SUBJECT: Forwards addl info re expansion of spent fuel storage capacity, in response to NRC 810127 request.

H. B. ROBINSON STEAM ELECTRIC PLANT UNIT NO. 2  
DOCKET NO. 50-261  
LICENSE NO. DPR-23  
REQUEST FOR ADDITIONAL INFORMATION CONCERNING  
SPENT FUEL POOL EXPANSION

AUXILIARY SYSTEMS BRANCH  
H. B. ROBINSON SFP EXPANSION PRELIMINARY QUESTIONS

FIGURE  
F

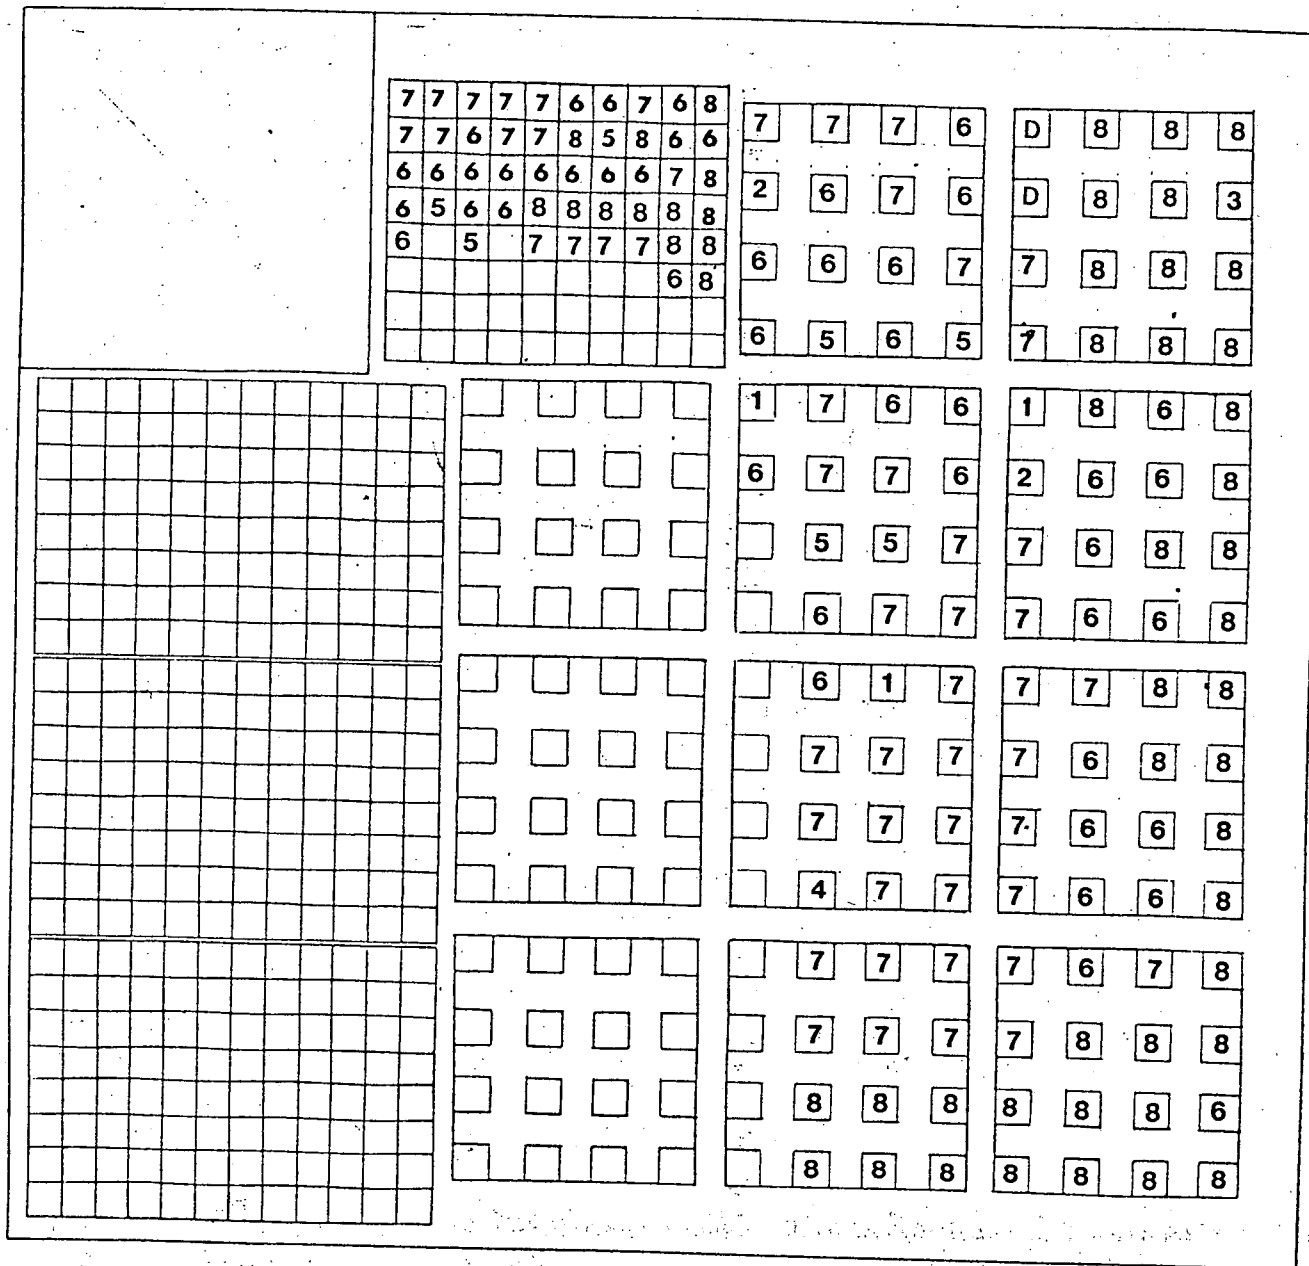
5. With the aid of drawings indicate the total number of fuel assemblies stored in the spent fuel storage pit as well as their location and decay times, in relation to the travel paths of the heavy load handling operations associated with the described modifications.

Figures A through G show the locations of the fuel assemblies stored in the spent fuel pool at present and after each fuel shuffle during rack installation. Fuel will be shuffled so as to keep the maximum possible distance between divers and spent fuel (approximately 9 to 10 feet). Therefore, spent fuel will not be in or near the work area or paths where racks are being removed or installed. No loads will pass over spent fuel locations. The discharge dates for the fuel assemblies identified in Figures A through G are as follows:

<u>Assembly Index</u>	<u>Discharge Date</u>
1	3-16-73
2	5-04-74
3	10-31-75
4	10-30-76
5	1-27-78
6	4-11-79
7	8-08-80
8	10-09-81 (projected)

SECTIONAL VIEW OF POOL

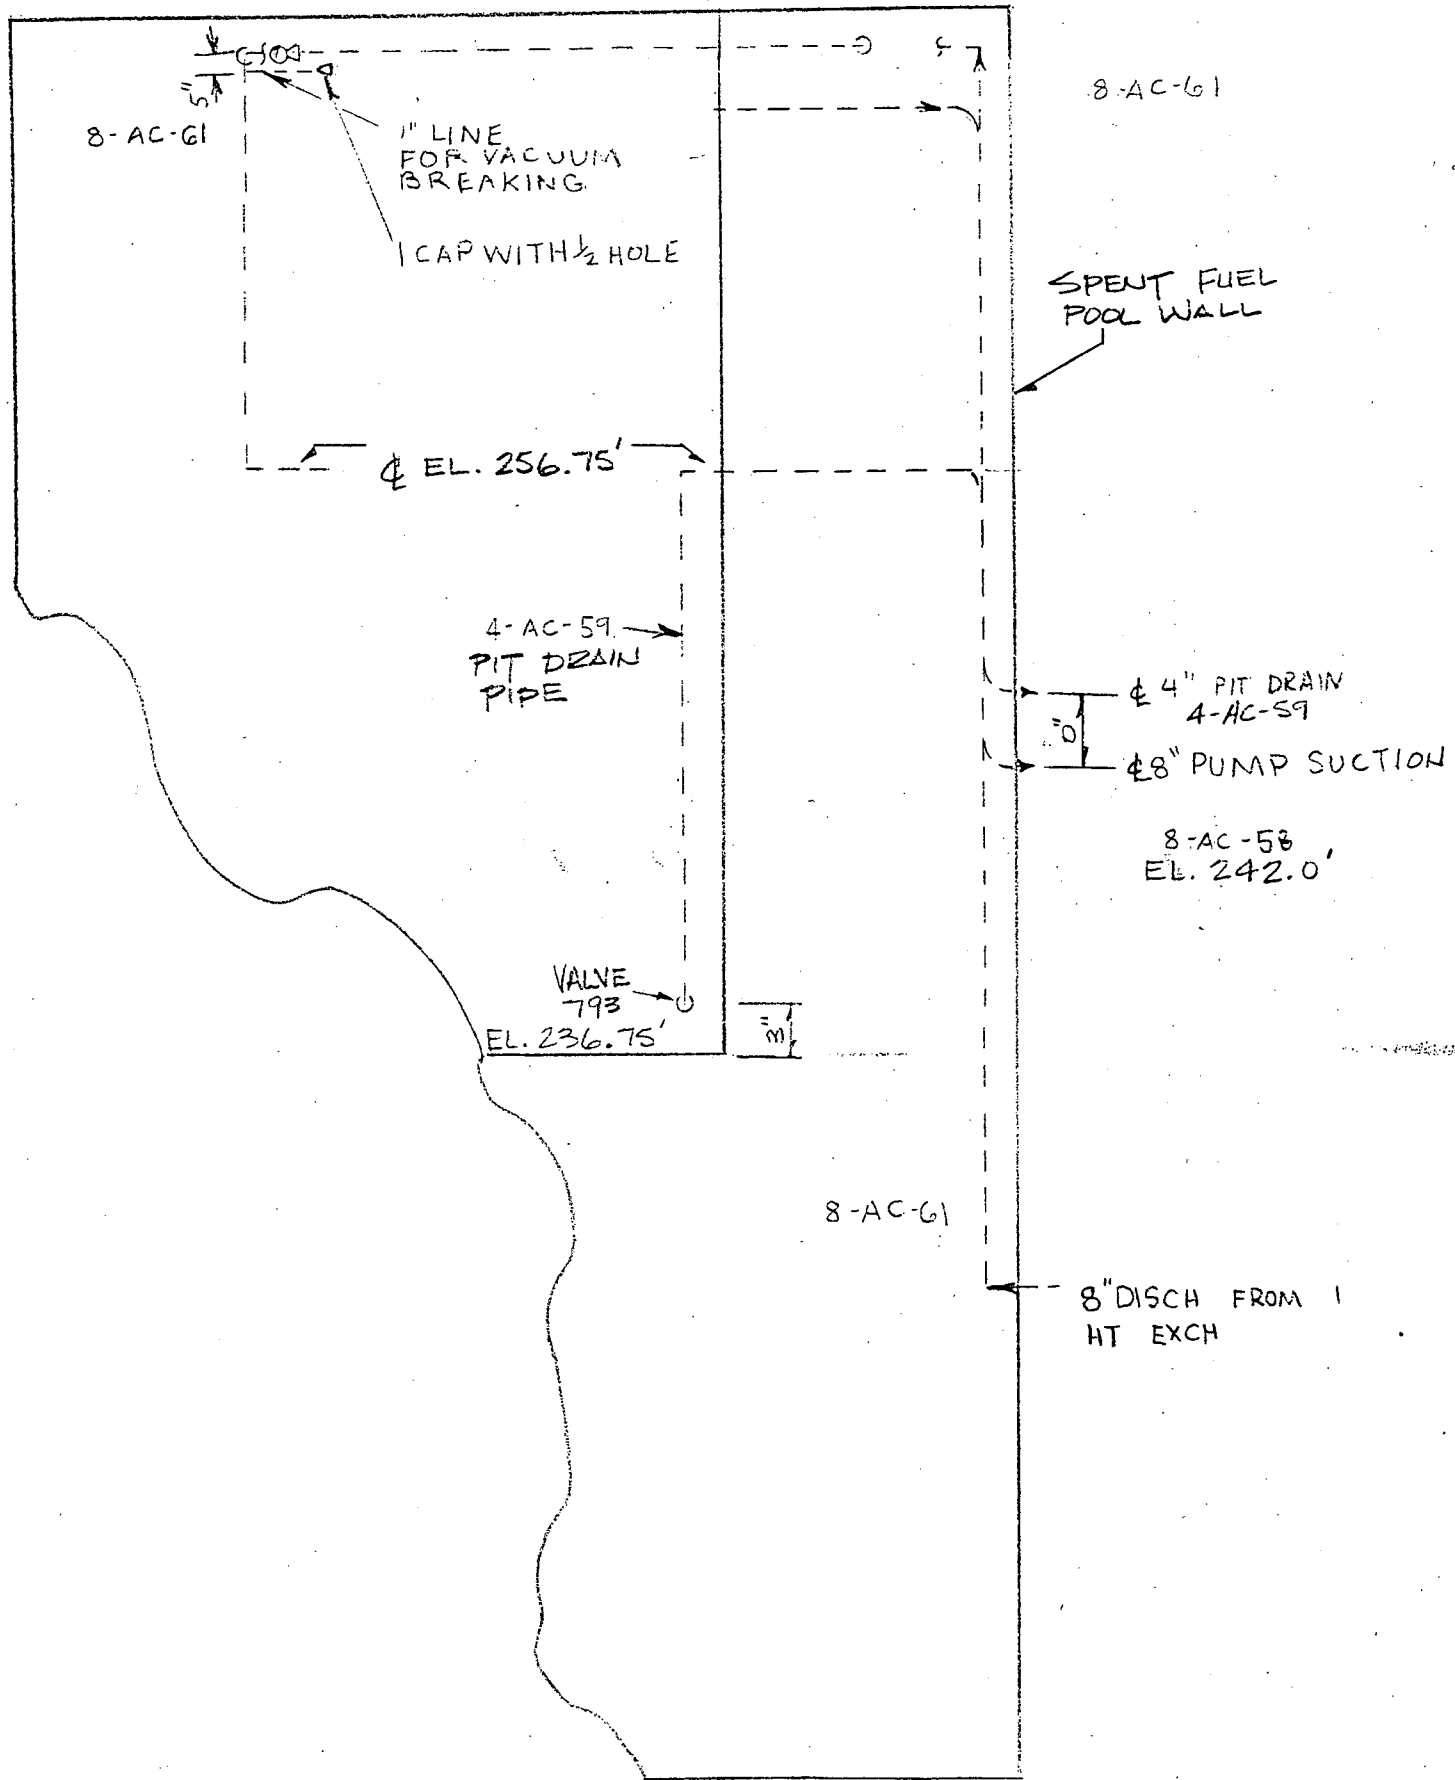
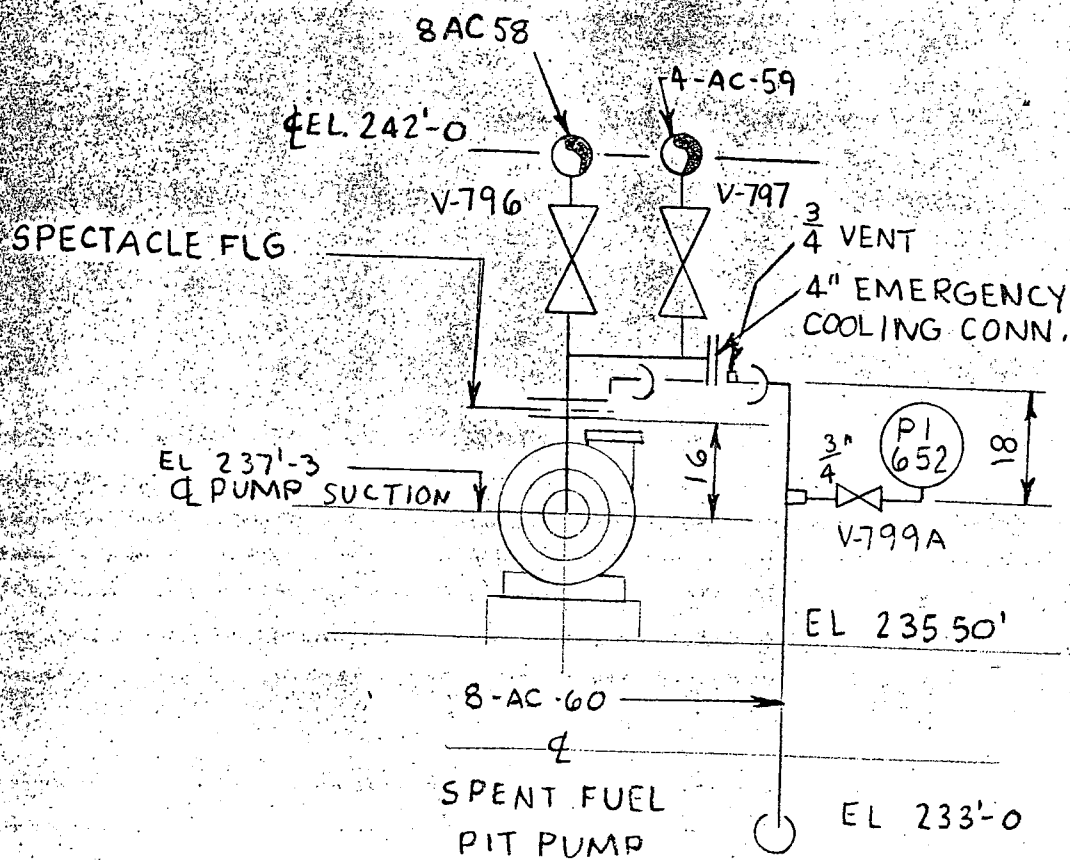
15. Position 6 of Regulatory Guide 1.13 states "Drains, permanently connected systems and other features that by maloperation or failure could cause loss of coolant that would uncover fuel should not be installed or included in the design." Section 9.3-3 of the FSAR indicates that a permanently installed drainage line exists which permits essentially all water to be removed.

- a. Describe how the existing design meets Regulatory Guide 1.13. The additional information is to include the possibility of valve 797 inadvertently being open and a line break permitting all water to be removed by siphoning or operation of the spent fuel cooling loop pump.
- b. Describe the pool water level, temperature, and radiation monitoring and alarm systems.
- c. Describe and discuss the merits of modifying the existing system, in order to bring it more clearly in compliance with Regulatory Guide 1.13, by replacing the permanently installed drain line with a removable section which would only be installed when the pool water level is to be lowered below its normal operating limits.

- a. The intent of Regulatory Guide 1.13 is met in the design in that the pool cannot be gravity drained below a level of 6 feet above the fuel assemblies due to the configuration of the drain piping (see enclosed figures). The drain inlet is approximately 3 inches above the bottom of the spent fuel pool. A locked closed valve, operable by means of a reach rod, is located at the drain pipe inlet. On the opposite side of the pool wall a normally closed valve is located upstream on the recirculation pump suction connection. No single failure will result in system integrity degradation to the extent that fuel assemblies will be uncovered. Should valve 797 be inadvertently left open and a break occur downstream, the pool would not drain due to the locked closed valve (Valve 793) at the pool drain inlet. A break upstream of Valve 797 (downstream of Valve 793) is unlikely because less than 12 inches of exposed piping is located in the spent fuel pool approximately 37 feet below the waterline and in an area of the pool where no routine activity occurs during the fuel movement. Additionally, the position of Valves 793 (locked closed valve at pool bottom) and 797 (normally closed valve in recirculation pump cubicle) are verified in Plant Operating Procedure 41B, "Initial Valve Lineup for Placing Cooling Loop in Operation." Utilizing these valves is not a normal operation and would be accomplished by means of a PNSC approved procedure. Therefore valve 797 being inadvertently left open and a line break occurring resulting in drainage of the pool below the fuel assembly storage level via siphoning or the recirculation pump is not considered a credible event.
